Recall Campaign Bulletin

Campaign No. 2023080004, August 2023

SUBJECT: **Model EQE (295 platform)**
Model Year 2023

Replace the Absorbers in the Roof Frame

Figure 1

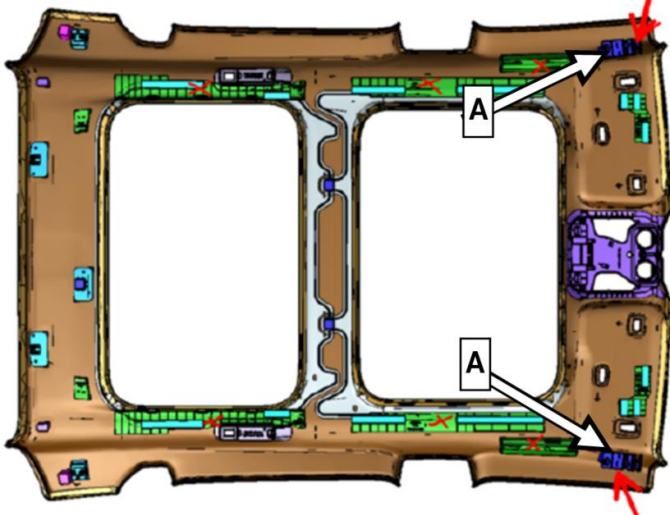
- Replace front absorbers on the left and right sides (**A**, **Figure 1**).

i The absorbers are clipped into the body-in-white under the headliner (**Figure 2**).
